## PIC12F629/675 Rev. A Silicon/Data Sheet Errata

The PIC12F629/675 parts you have received conform functionally to the Device Data Sheet (DS41190C), except for the anomalies described below.

## Clarifications/Corrections to the Data Sheet:

#### REGISTER 3-2: TRISIO – GPIO TRI-STATE REGISTER (ADDRESS: 85h)

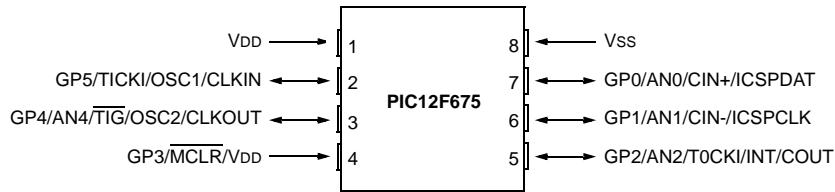
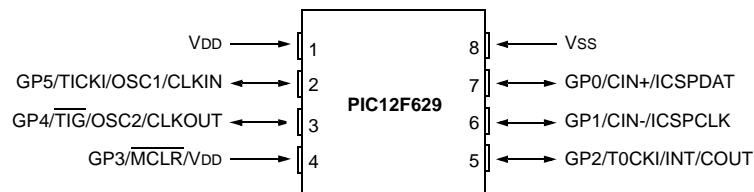
Register 3-2, "TRISIO – GPIO Tri-state Register (Address: 85h)", is incorrect. Bits 5-4 and 2-0 should read "R/W-1", as shown below:

U-0	U-0	R/W-1	R/W-1	R-1	R/W-1	R/W-1	R/W-1
—	—	TRISIO5	TRISIO4	TRISIO3 <sup>(1)</sup>	TRISIO2	TRISIO1	TRISIO0

## 8-Lead Plastic Dual Flat No Lead Package (MD) 4x4x0.9 mm Body (DFN) – Saw Singulated

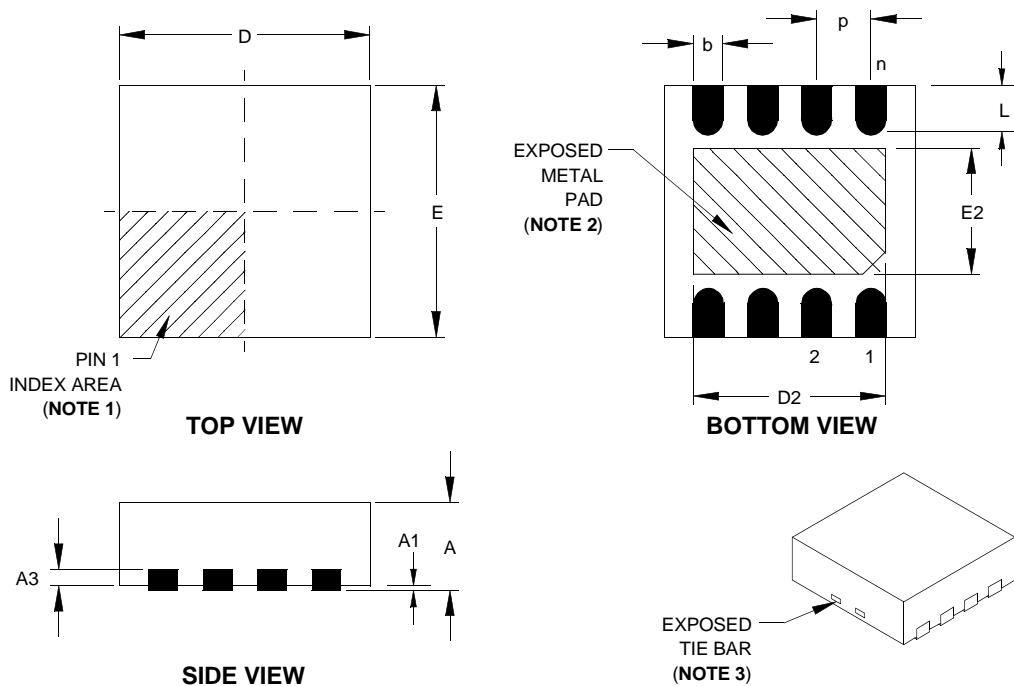
## 2. Module: New 4x4 DFN Package Added

The new 8-pin 4x4 DFN pinout diagram will be added to the Pin Diagrams figure on page 2 and the Packaging Information chapter as shown below:
